Goose & MLA Project Sites – 2023 Annual Geotechnical Inspection

Back River Project, Nunavut, Canada
B2Gold Corp.

SRK Consulting (Canada) Inc. ■ CAPR003105 ■ April 2024

Date: 2024-02-28	Approved: JBK	Figure: 5
---------------------	------------------	---------------------

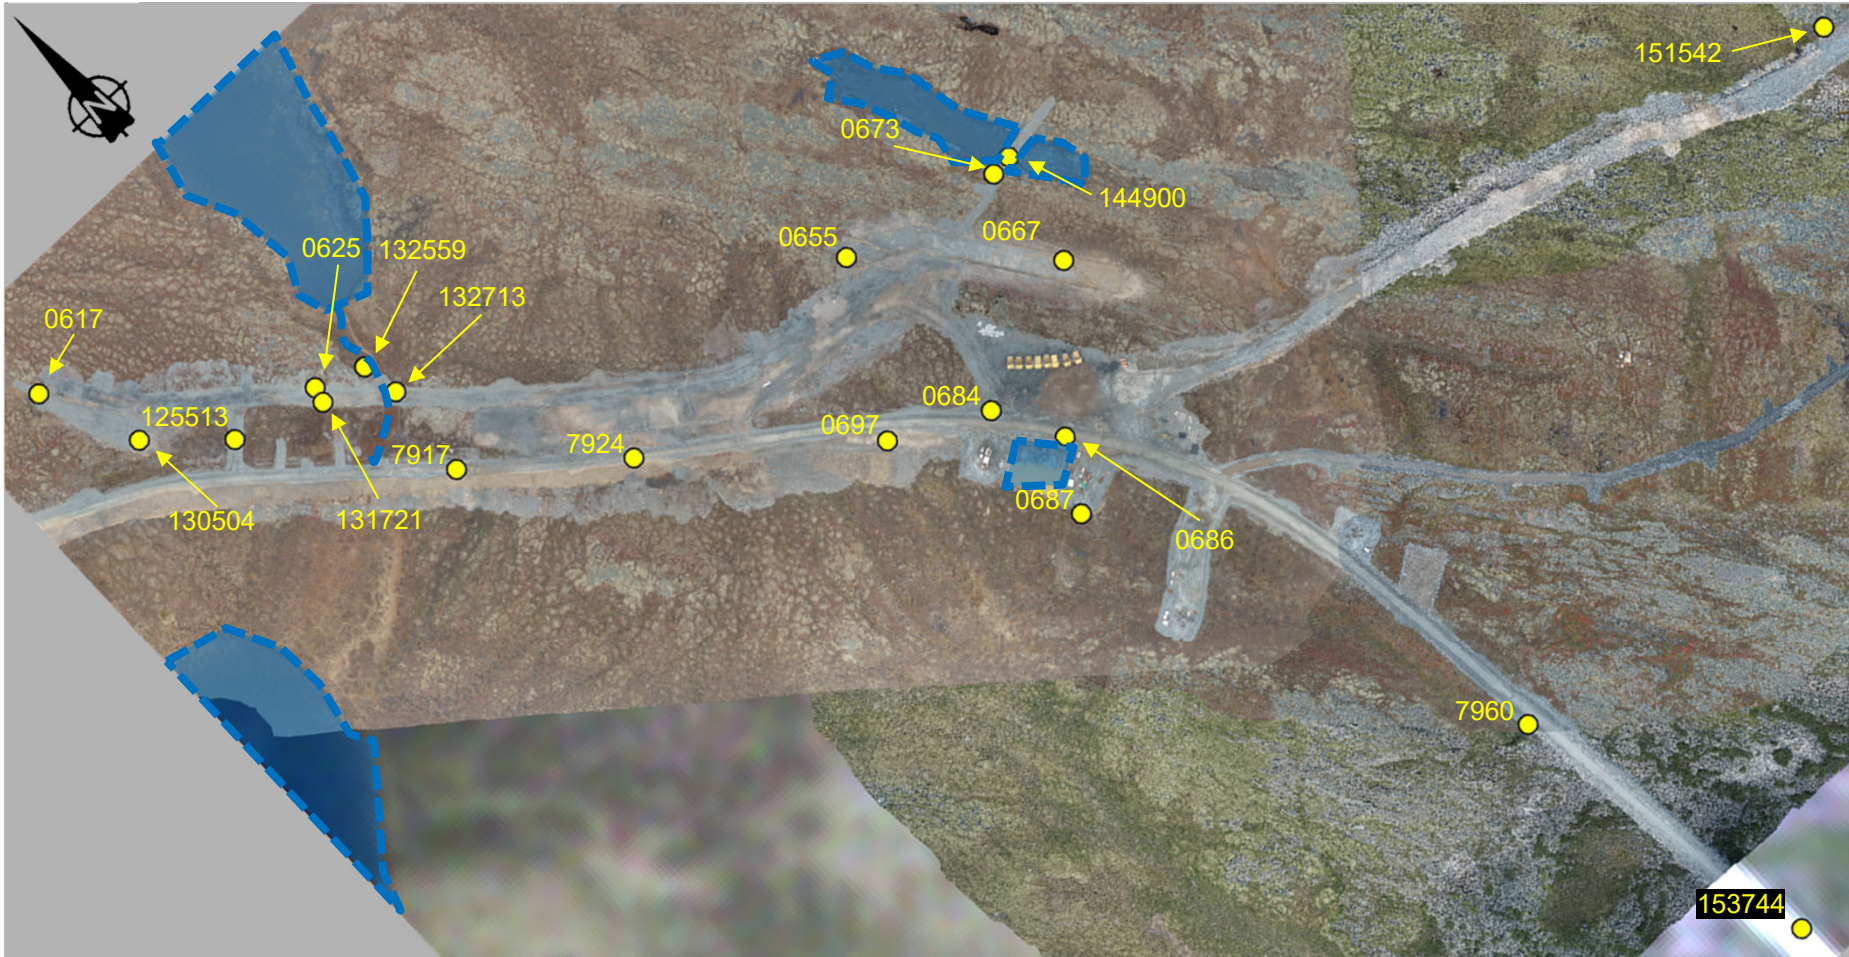
- The Goose airstrip extension to the South is currently in progress. As this airstrip extends to the south, it intersects some more notable surface water flow pathways / ephemeral streams. The South end of the extended Goose Airstrip is expected to be an area that will need to be closely monitored and more permanent long term water conveyance through portions of the airstrip is expected to be required.

- Goose airstrip extension to the South is currently in progress. As this airstrip extends to the south, it intersects some more notable surface water flow pathways / ephemeral streams (Figure 5). The Rascal Diversion berm started to be constructed in October – November 2023 (Appendix D) and should be completed before the 2024 freshet if the airstrip is planned to be extended further south or used in the areas where the main natural surface water flow paths are intersected. The South end of the extended Goose Airstrip is expected to be an area that will need to be closely monitored and more permanent long term water conveyance through portions of the airstrip should be considered by site (again depending on the length and use of the airstrip that site is targeting).

2023 Annual Geotechnical Inspection		
		Ponding Water MLA Airstrip		
Job No: CAPR003105 Filename: BackRiver_2023AGI_Figures..pdf	Back River Project	Date: 2024-02-28	Approved: JBK	Figure: 11

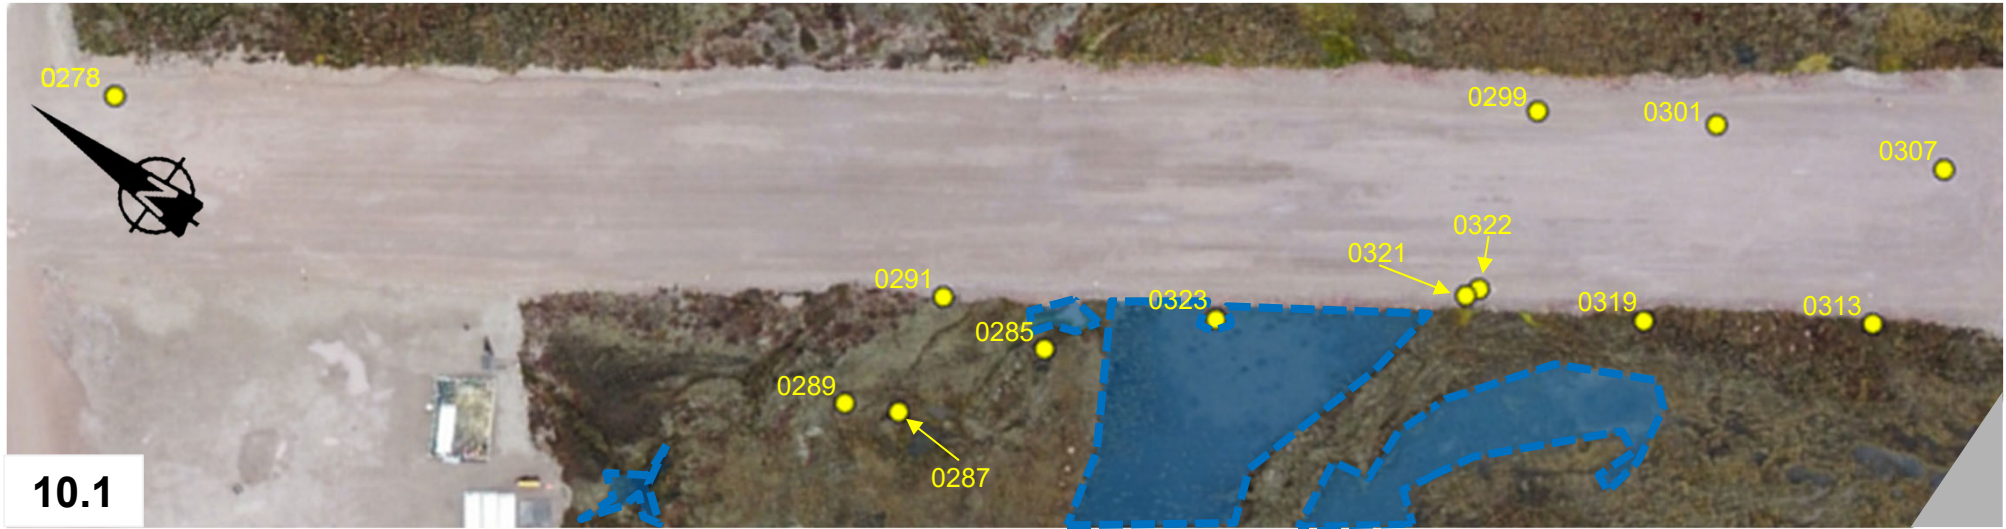
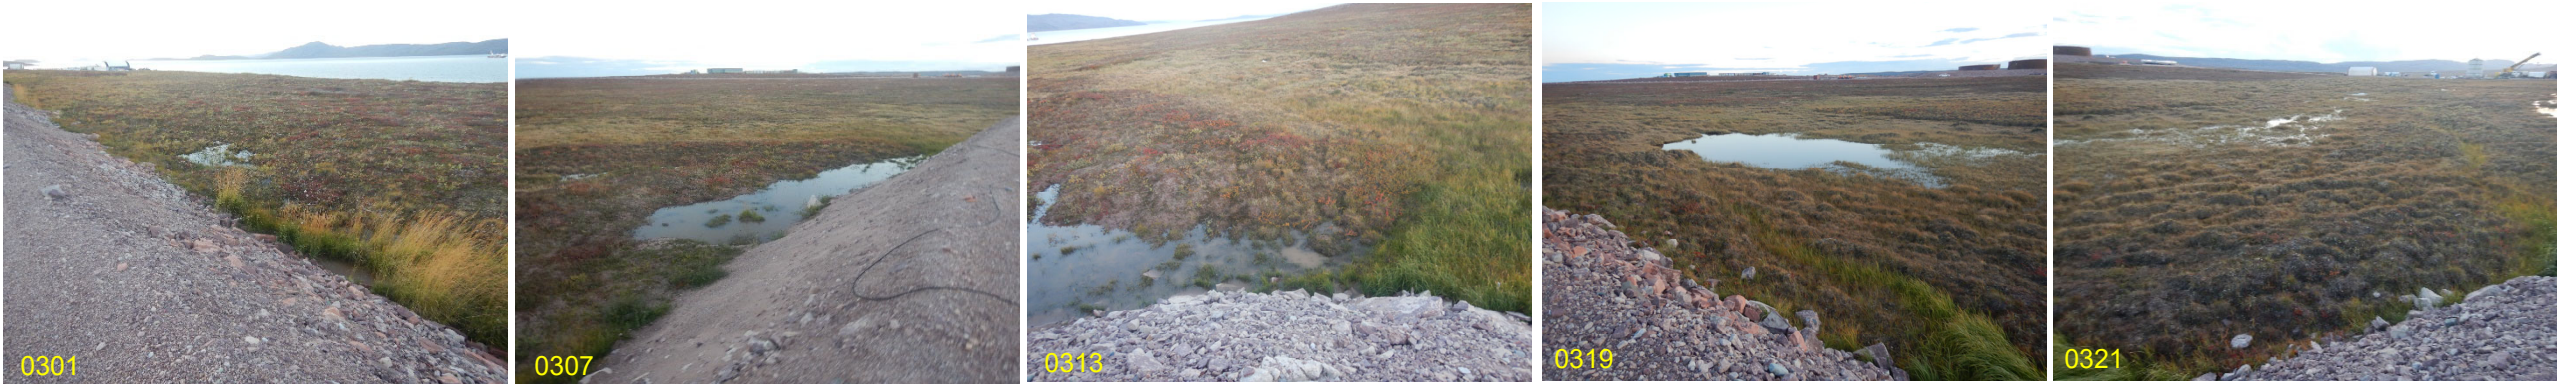
- At the MLA there is ponding water against the southern-to-southern western edges of the airstrip (Figure 11). B2Gold should monitor these areas (specifically as temperatures annually warm on site from winter to spring to summer conditions). Some consideration should be given to redirecting or trying to push any ponding water further away from the toes of the existing MLA airstrip. This could be done in an attempt to push any thermal degradation further away from the main airstrip fill. Pumping down / removal of any ponded water at the toes of the airstrip in the fall (before winter freeze-up) would increase the cold ambient air and ground heat transfer to help slow down permafrost degradation (reduce thawing rates and slow deepening of the active layer). This increased water management may help to reduce overall maintenance activities at this airstrip.
